Smoke Detector location Recall

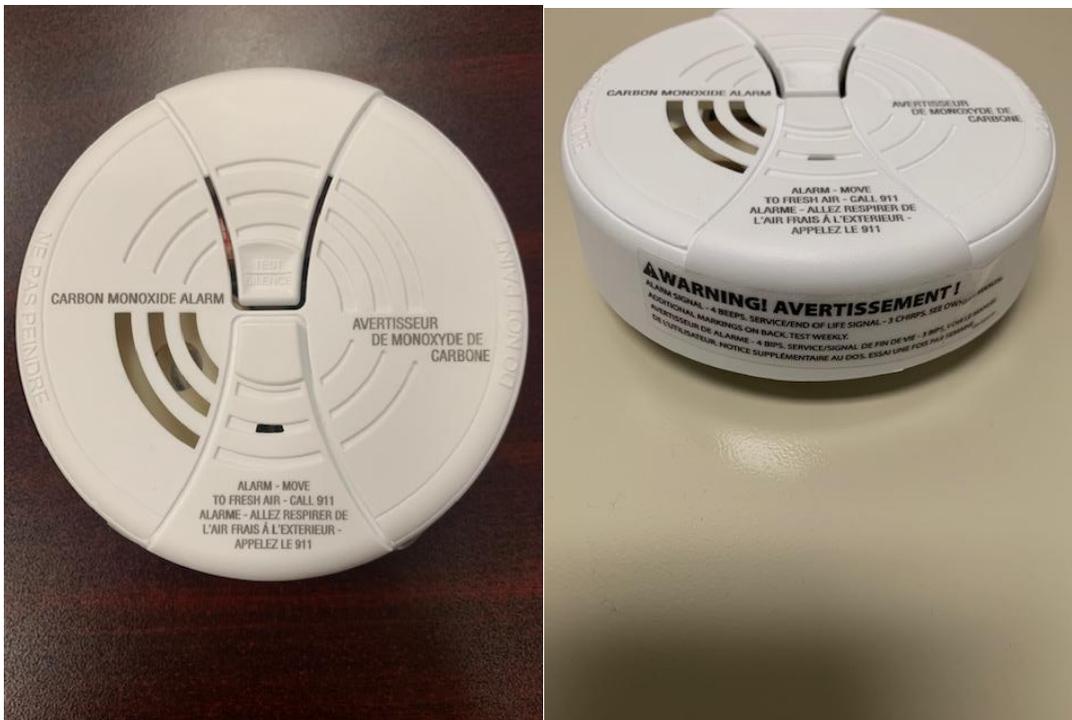
On certain fifth wheel trailers the smoke detector may not have been properly located inside of the bedroom area. If the unit has a C/O detector and smoke detector please verify that the smoke detector is NOT located in the bedroom. If the smoke detector is in the bedroom it needs to be switched with the C/O detector located at the top of the stairs. If the unit is equipped with a combination LP-C/O detector and switching the smoke detector is not an option then an additional smoke alarm needs to be installed in the main body of the unit. Please see pictures below to show the difference between the C/O detector and smoke detector.

The pictures above show the C/O detector which should be located in the bedroom if the unit is not equipped with the combination LP-C/O detector. The C/O detector has gray lettering that says, “Carbon Monoxide Alarm” on the face and a warning sticker located on the side.
